Serial No.:	10/604,375	Art Unit:	2818
-------------	------------	-----------	------

### **REMARKS**

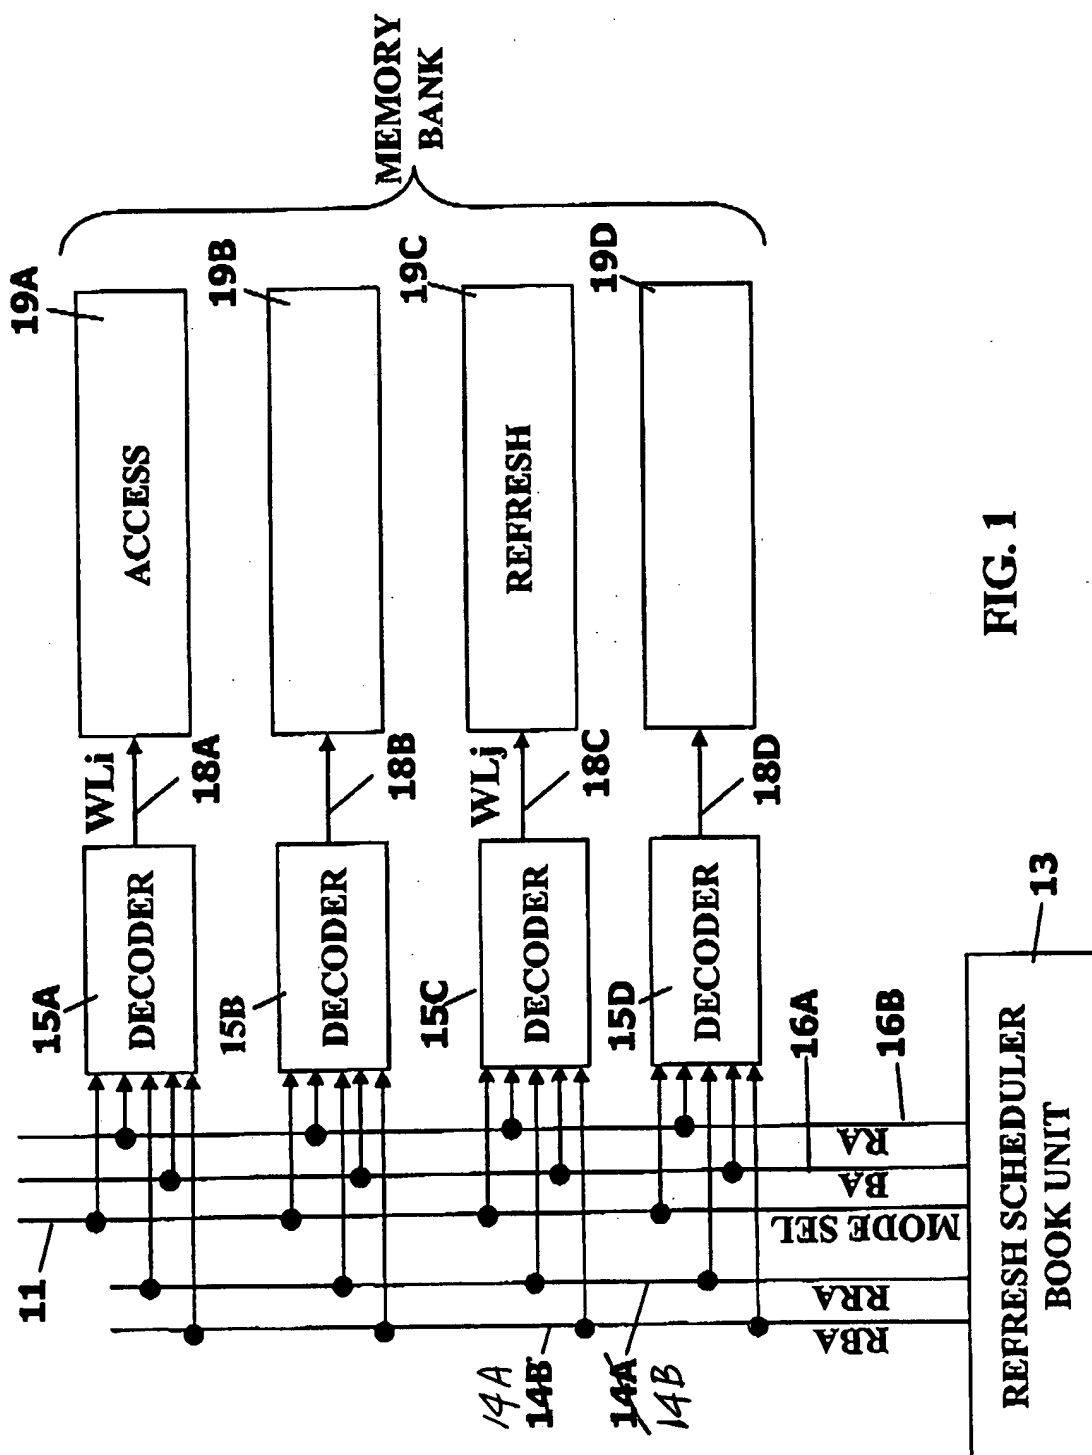
With respect to FIG. 1, reference signs ACCESS, REFRESH , WLi, 18A , 18B, WLj, 18C, and 18D are described in amended paragraph [0022]. In addition, FIG. 1 has been amended to reverse reference signs 14A/14B to be consistent with other drawing in which the reference signs are reversed. The specification has been amended to be consistent with these changes.

**FIG. 2A**

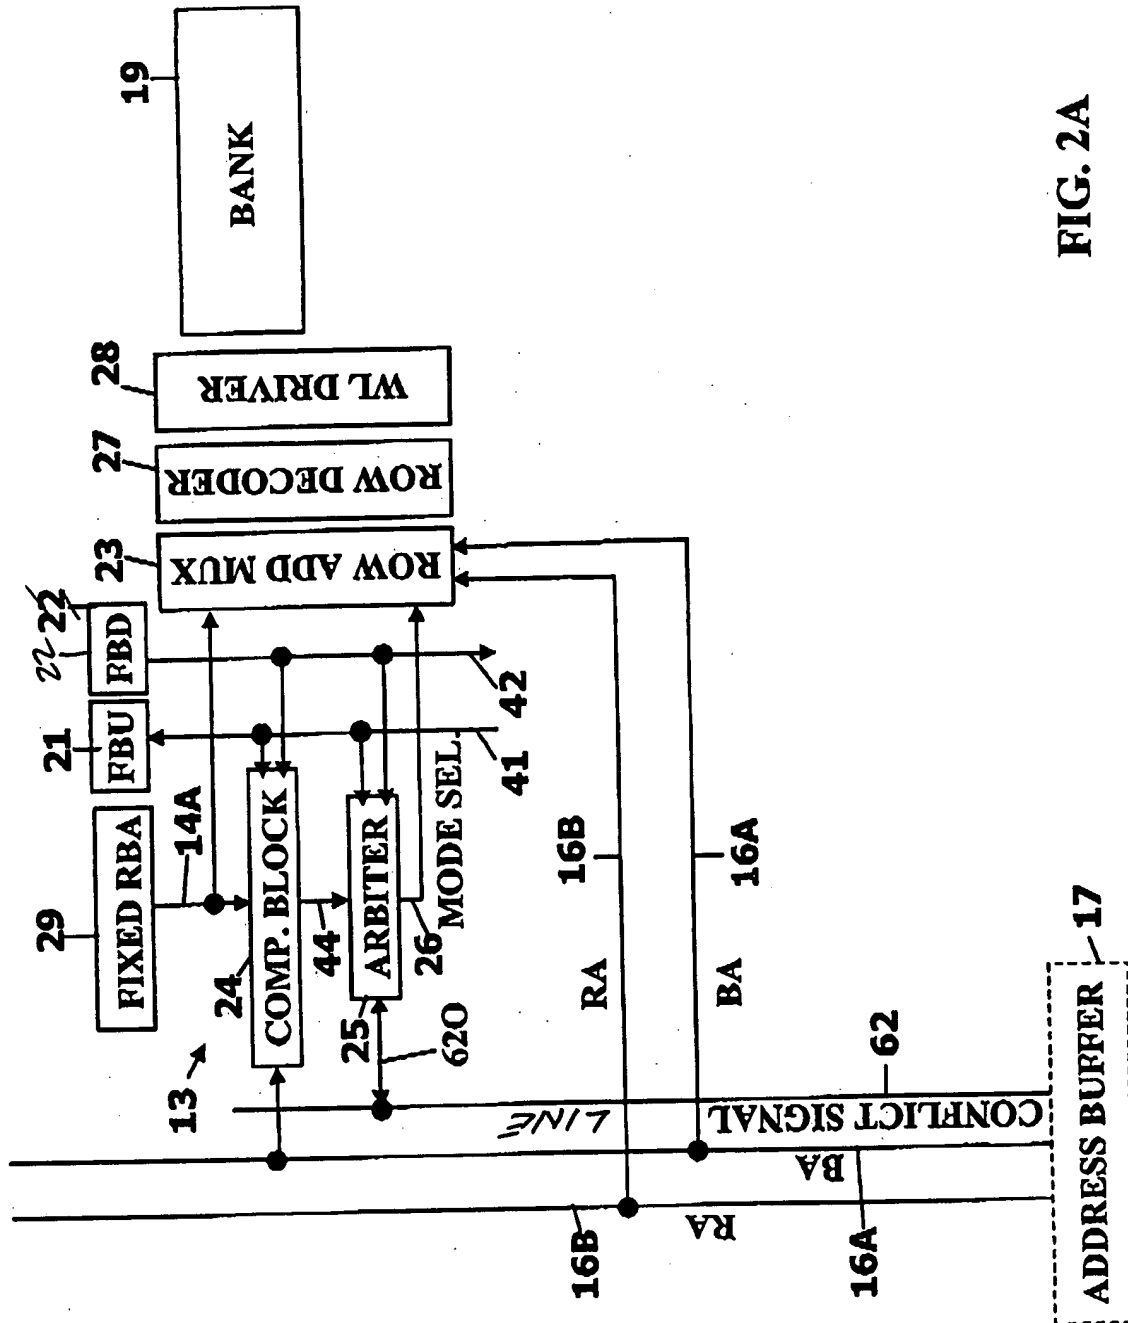
With respect to FIGS. 2A, 2B, and 5, reference sign 62O is described in amended paragraphs [0029], [0037], [0048], [0052], [0062], [0065], [0066], and [0068]. In FIGS. 2A and 2B, the line 62 has been marked as "Conflict Signal Line" by adding the word Line as

indicated in the specification in paragraph [0029], etc. In FIG. 2A, the reference sign 22 has been centered over the FBD box. In FIG. 2B, the reference sign 62 has been added. In FIGS. 2A, 2B, the indicia (n-1), (32) and (0) are now in parentheses in boxes 19Z, 19Y and 19X, as indicated in the amended paragraph [0024].

A conflict signal line 62 (line 11, page 8): See FIG. 2A and revised paragraph [0029].  
line 31 (line 3, page 9); [0032]

Fixed Refresh Bank Address (Fixed RBA): line 14B (lines 13-14, page 10): See amended paragraph [0026] and original and revised FIG. 2A.

**FIG. 6D**

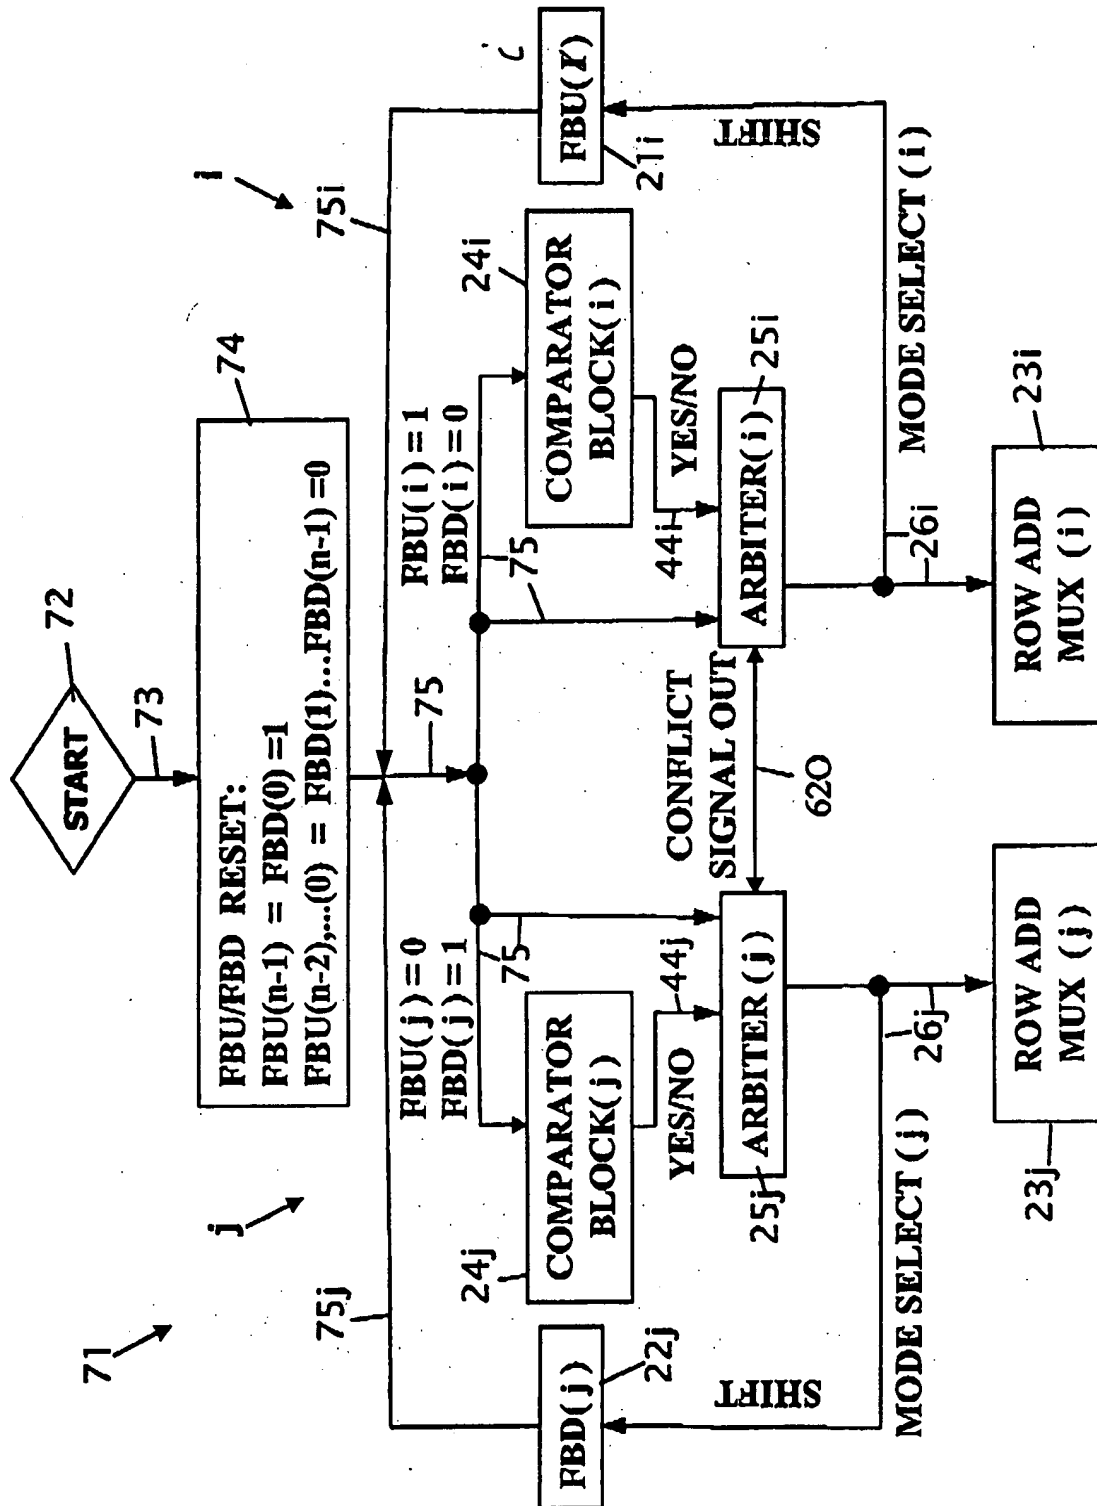
With respect to FIG. 6D, the changes have been made as follows:

The reference sign 71 is now described in amended paragraph [0041]; the reference sign FBU(n-2),...(0) is now described in amended paragraph [0044]; the reference signs FBD(j) and 22j, 21i and 62O are now described in amended paragraph [0048]; and the drawing in FIG. 6D has been corrected so that reference sign "FBU(I)" now reads "FBU(i)", as is described in amended paragraphs [0046], [0048], and [0051].

FIG. 7

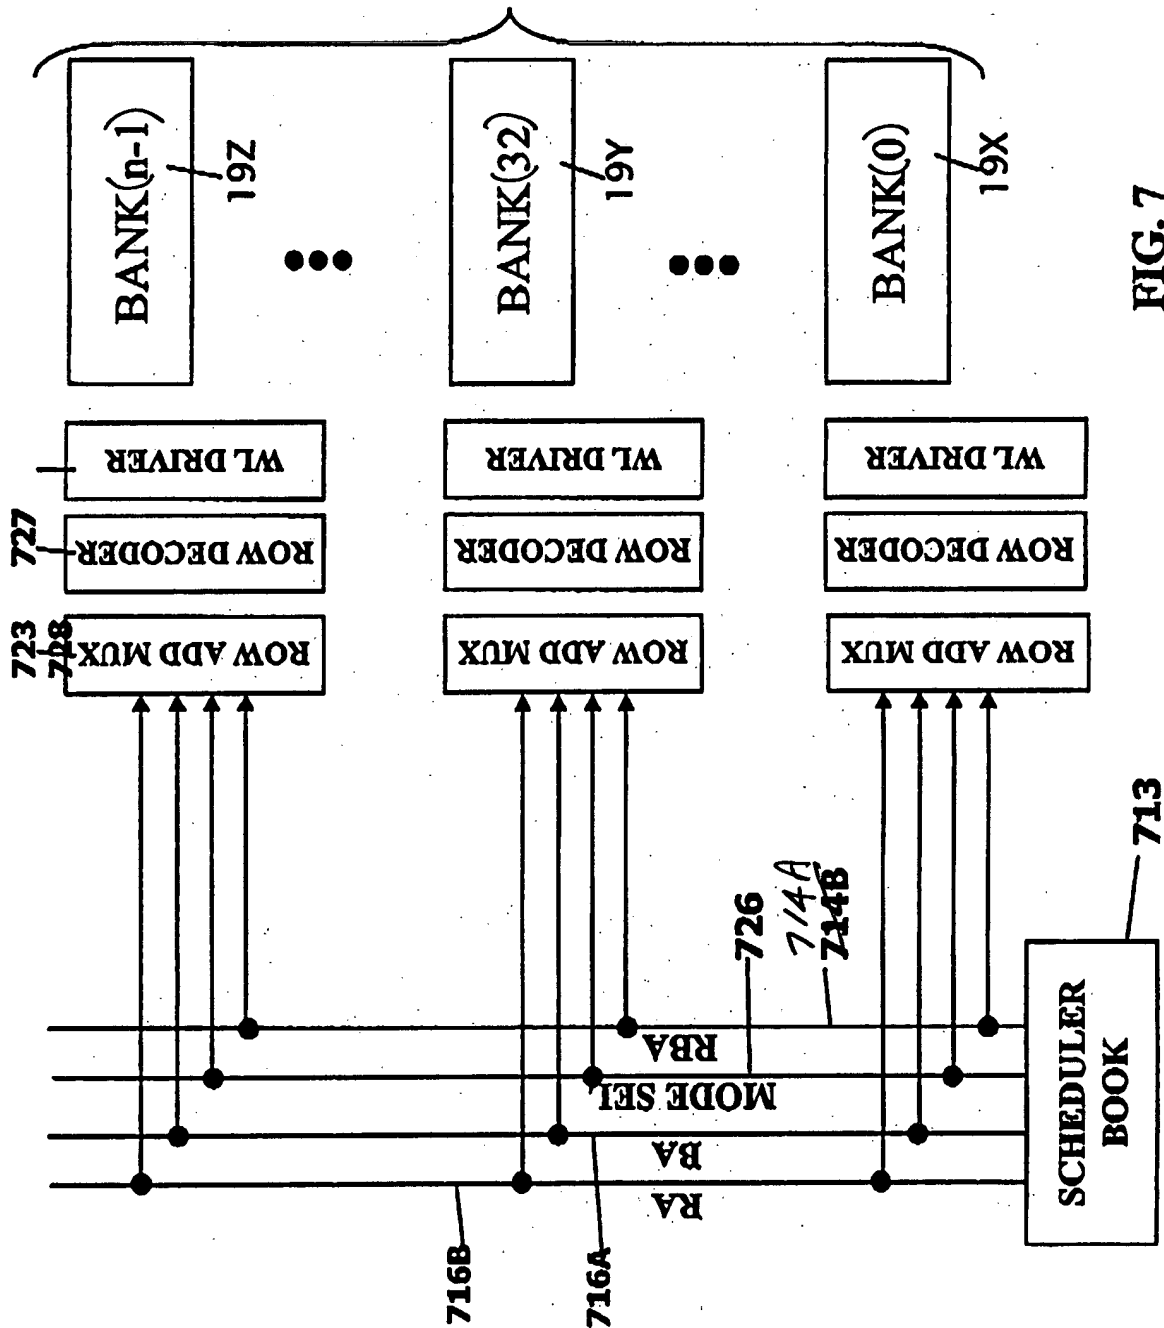
With respect to FIG. 7, reference signs 726, 723, 727, and 728 are described in amended paragraph [0059]. The reference sign "714B" has been amended to read "714A" to match the numbers 16A in FIGS. 1, 3, and 4 and the reference sign "714A" is also described in amended paragraph [0059]. The reference sign 728 has been relocated over the WL Driver where it was intended to be located to correct an inadvertent drafting error. As in FIGS. 2A, 2B, the indicia (n-1), (32) and (0) in FIG. 7 are now in parentheses in boxes 19Z, 19Y and 19X, as indicated in the amended paragraph [0059].

FIG. 8

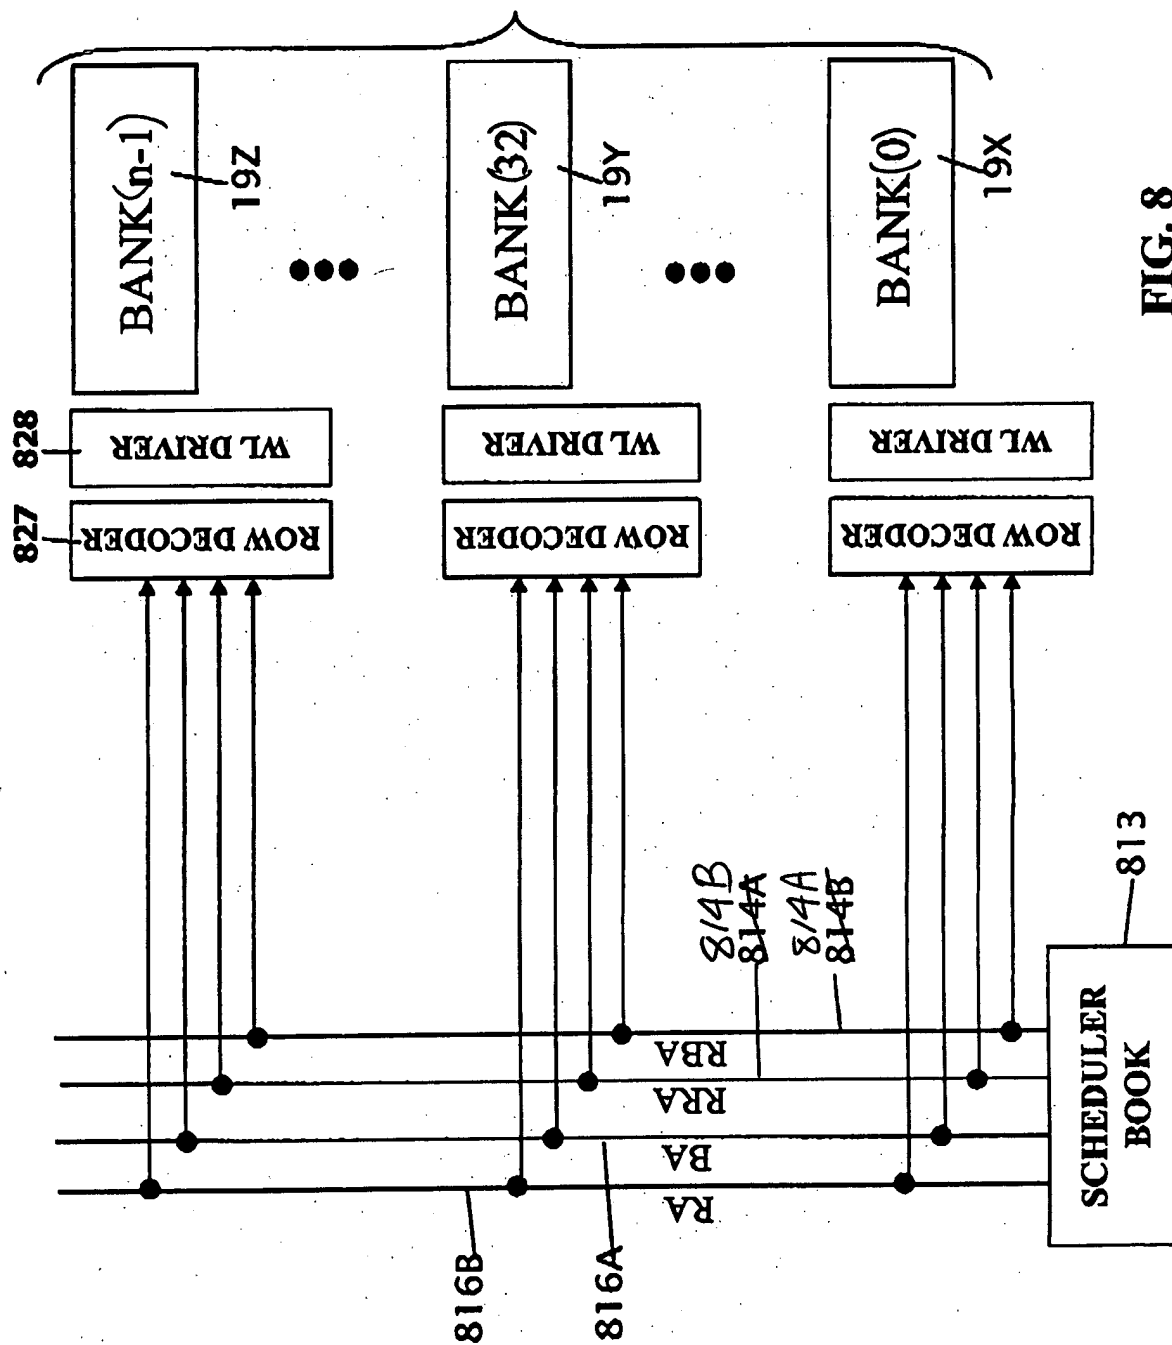
With respect to FIG. 8, reference signs 827 and 828 are described in amended paragraph [0060]. In addition, FIG. 8 has been amended to reverse reference signs 814A/814B to be consistent with other drawing in which the reference signs are reversed.

The paragraph [0060] of the specification has been amended to be consistent with these changes. As in FIGS. 2A, 2B, and 7 the indicia (n-1), (32) and (0) in FIG. 8 are now in parentheses in boxes 19Z, 19Y and 19X, as indicated in the amended paragraph [0060].
